**PUBLIC UTILITIES COMMISSION**

**Re: Request for Information Regarding Proposed Sunrise Powerlink  
Transmission Project, Application No. 06-08-010**

## ATTACHMENT 1

Figure 1: Misaligned corridors

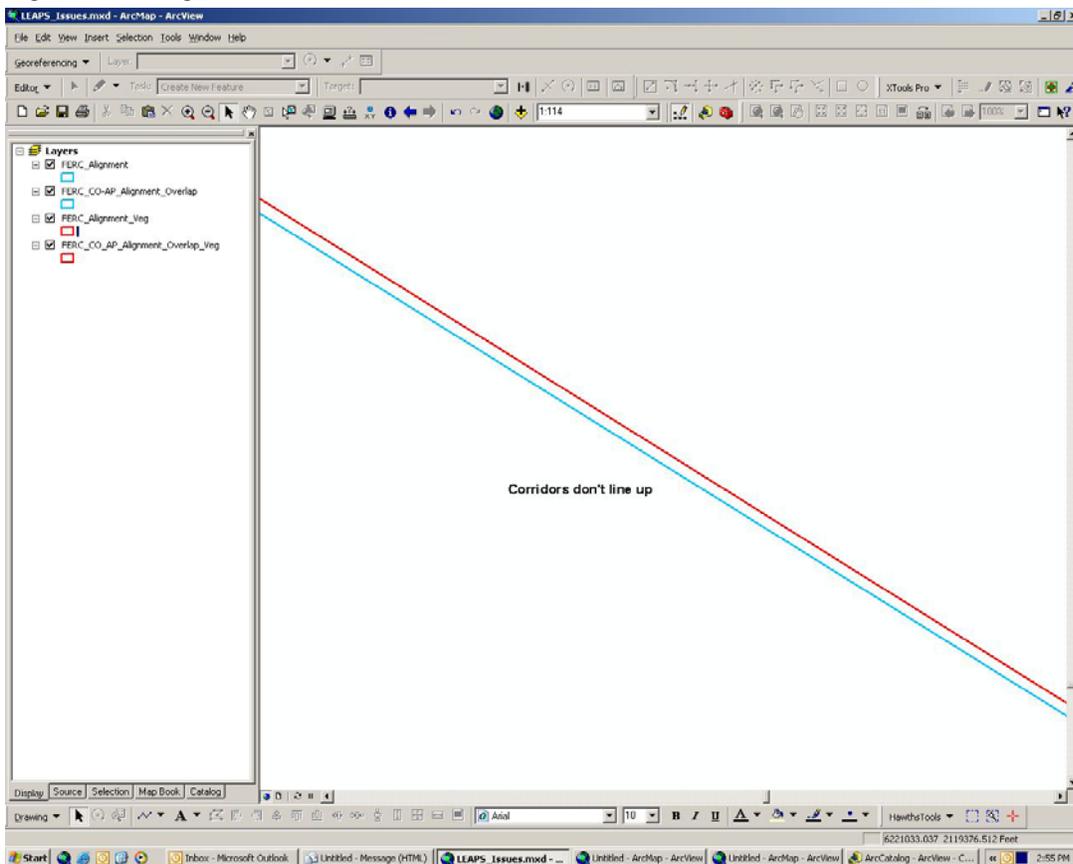
1. As shown in Figure 1 (on the following page), the corridor shown in the vegetation file (FERC\_Alignment\_Veg and FERC\_CO\_AP\_Alignment\_Overlap\_Veg) does not line up with the regular corridor alignment (FERC\_Alignment and FERC\_CO AP\_Alignment\_Overlap). Please provide us with files showing the same transmission centerline.
2. As demonstrated in Figure 2, there are a considerable number of slivers in the vegetation mapping (gaps where vegetation polygons do not line up). In other places the vegetation polygons overlap, as shown in Figure 3. Please correct the data so there are no data gaps and no data is overlapping.
